SAFETY EVALUATION BY THE OFFICE OF NUCLEAR REACTOR REGULATION

SUPPORTING AMENDMENT NO. 14 TO LICENSE NO. DPR-28

(CHANGE NO. 25 TO TECHNICAL SPECIFICATIONS)

VERMONT YANKEE NUCLEAR POWER STATION

Figure 6.1.1 CORPORATE ORGANIZATION

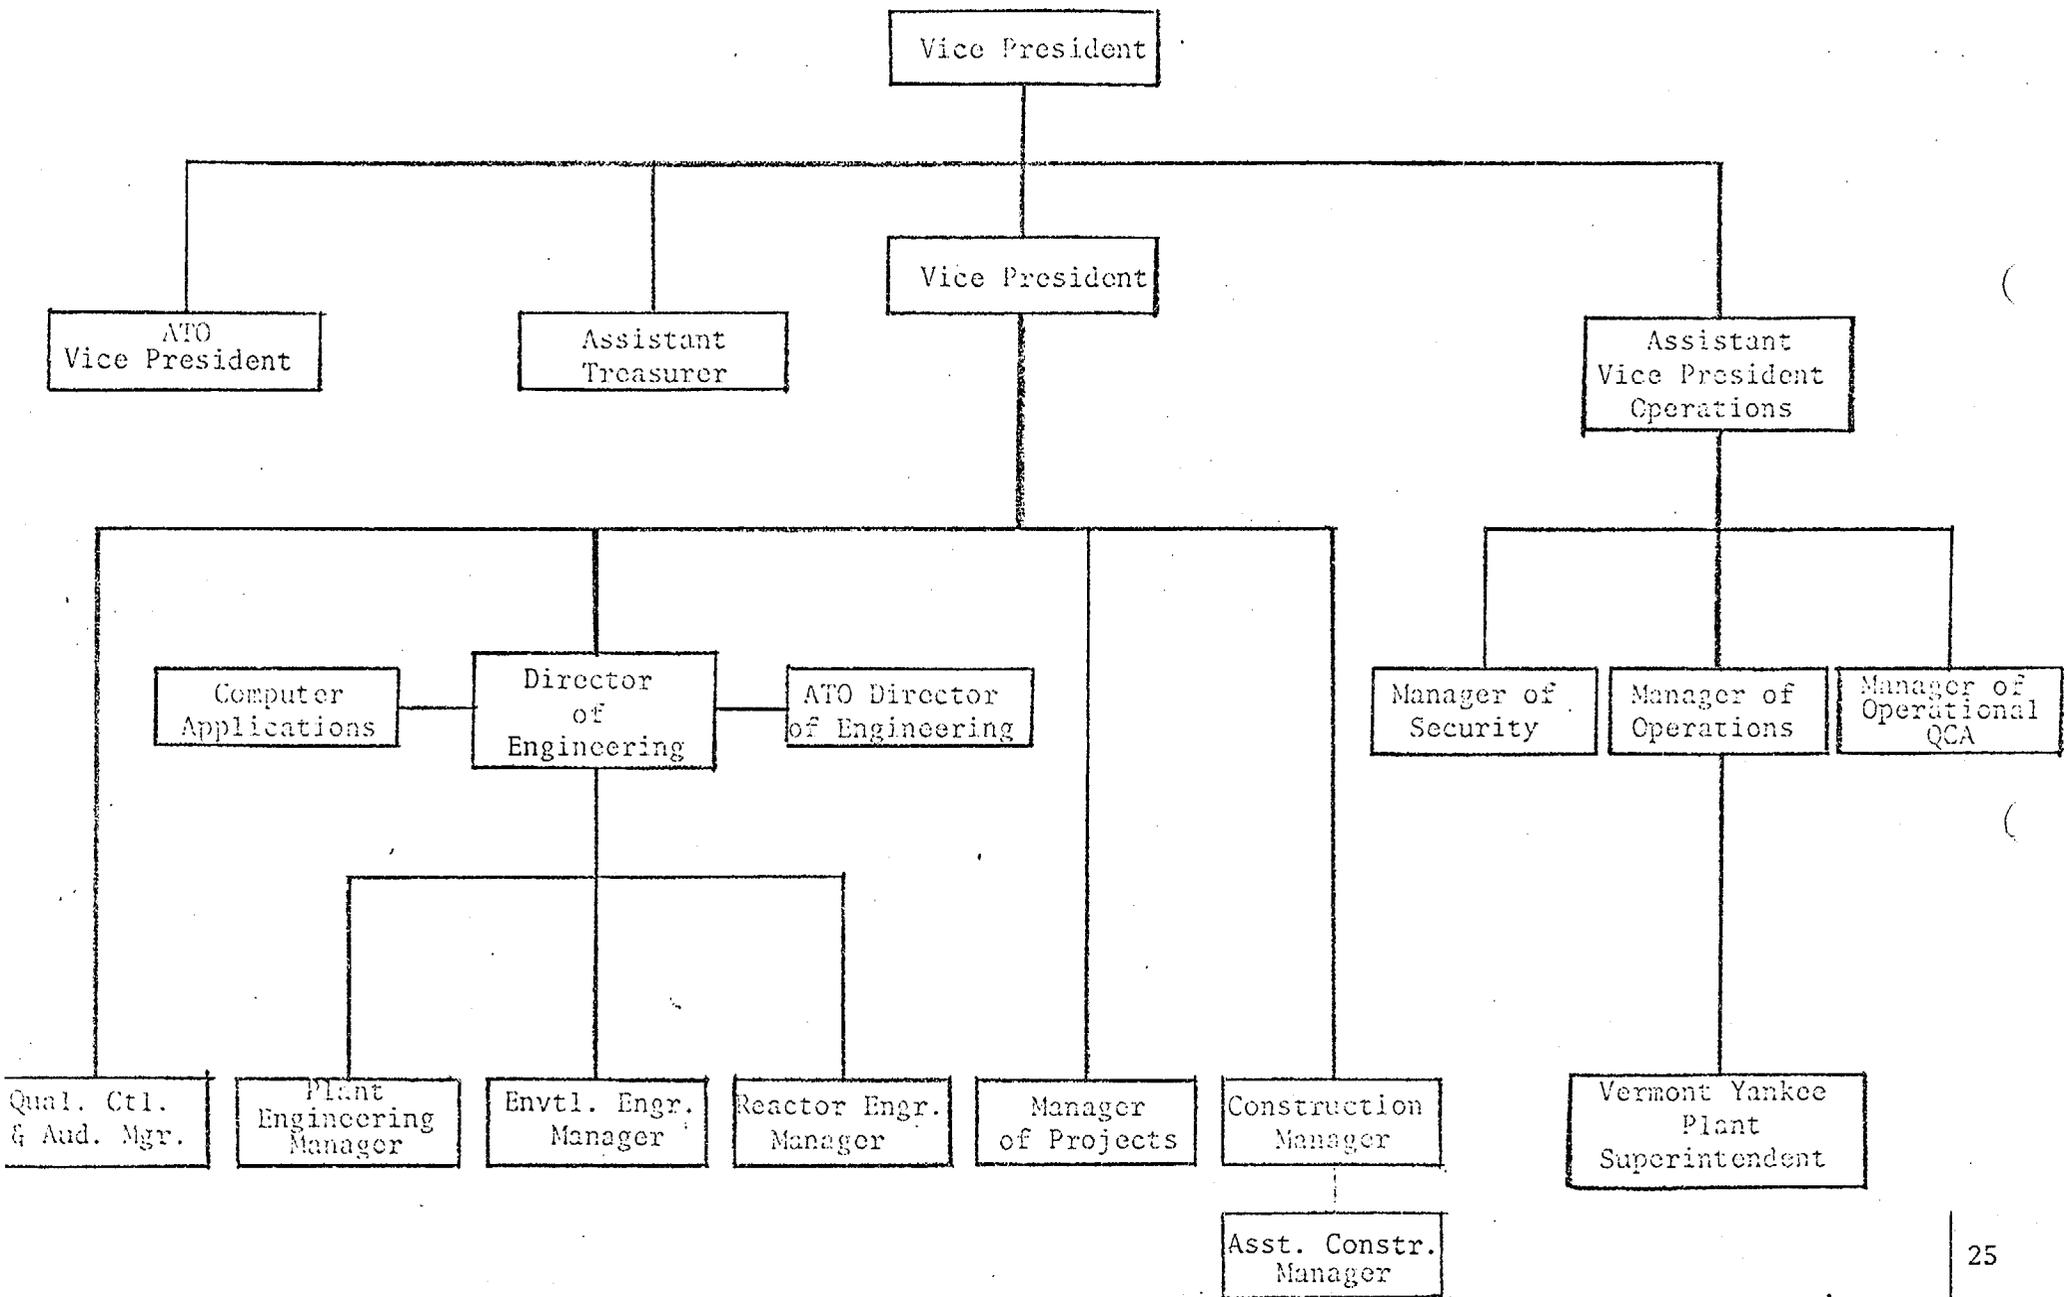
Figures 6.1.1 and 6.1.2 have been changed to reflect the current organization at the corporate and operations level. Consistent with the increased importance placed on security matters and quality control independence, the corporate organization chart shows these groups to be reporting directly to the assistant vice president for operations. The other changes are minor

FIGURE 6.1.2 NORMAL FUNCTIONAL ORGANIZATIONAL CHART

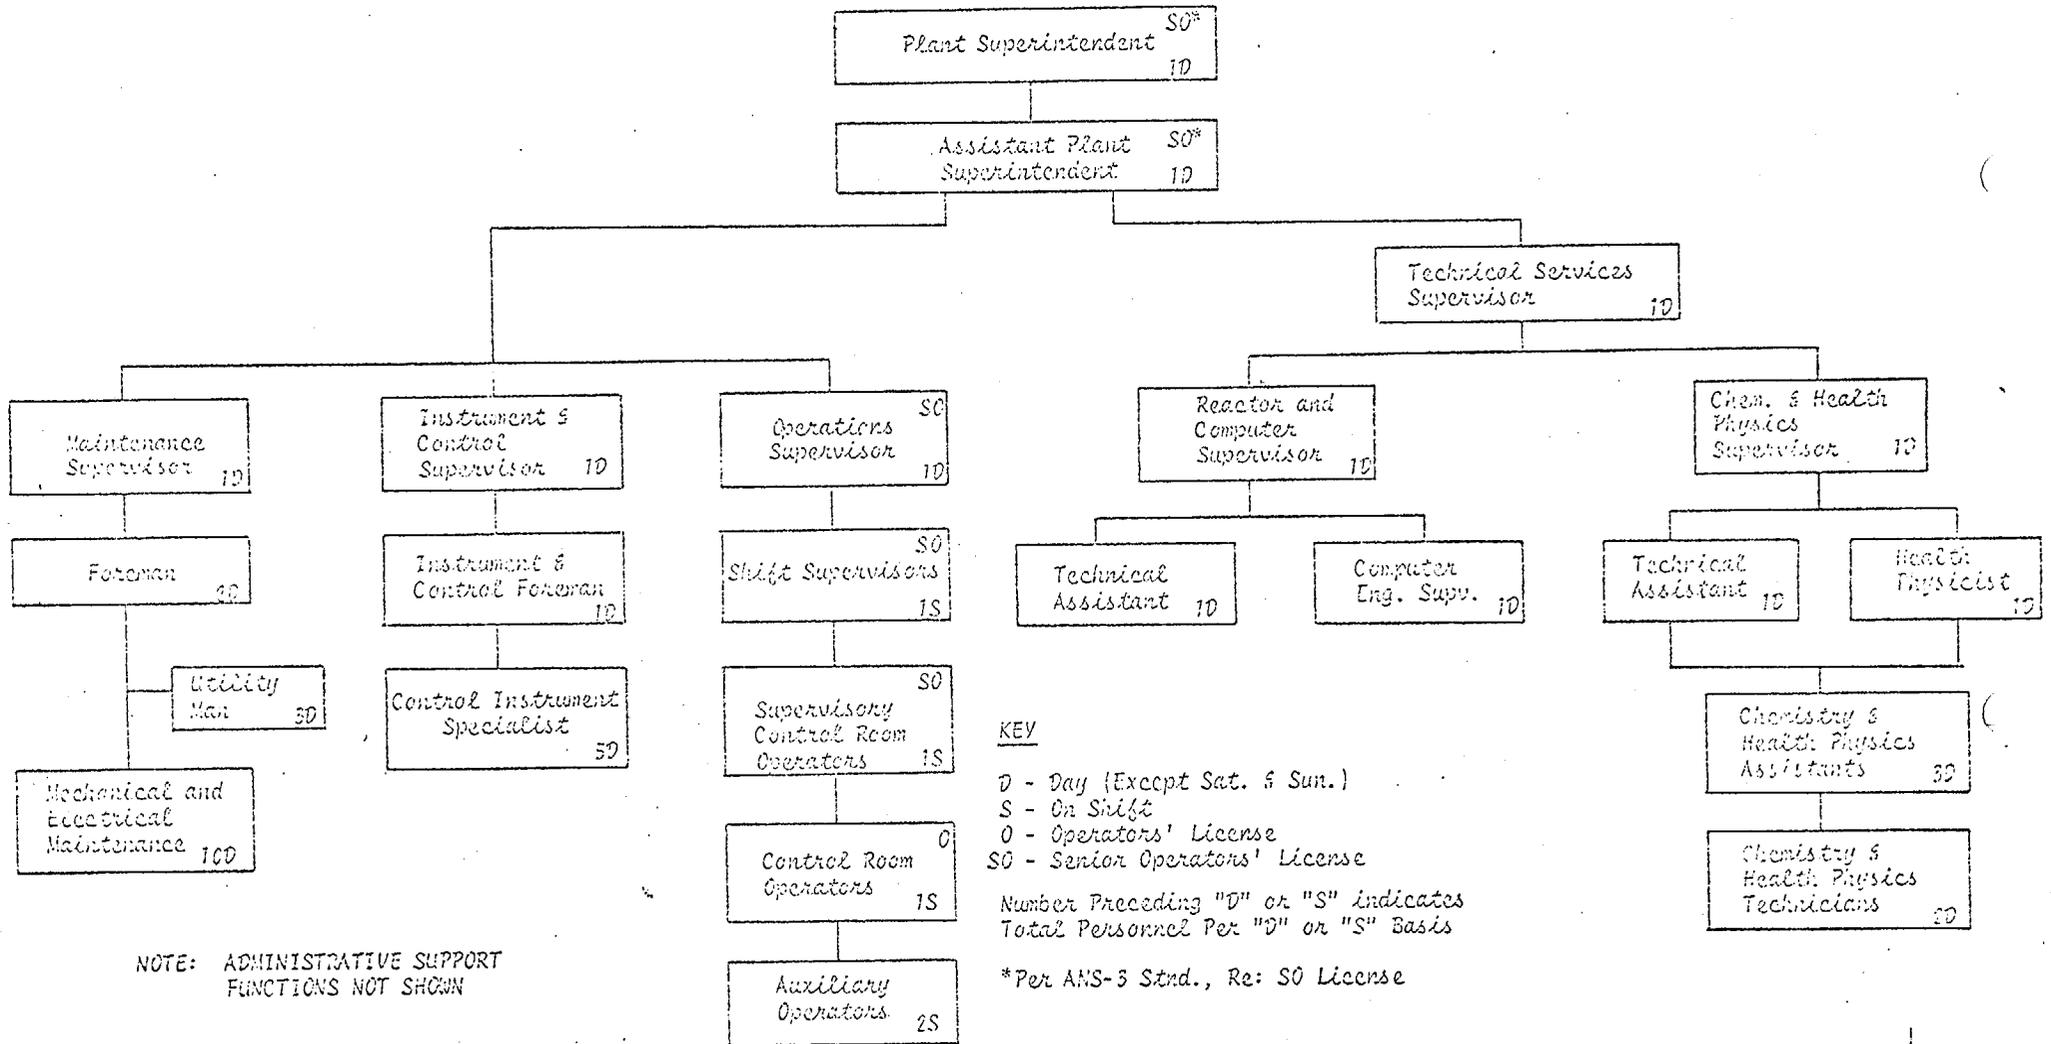
and do not affect the operation of the facility. The only change to the operation organization is the addition of a technical services supervisor to direct all technical services for plant operation. The remaining operations groups continue to report directly to the plant superintendent. These changes should improve the effectiveness of the organization and therefore are acceptable.
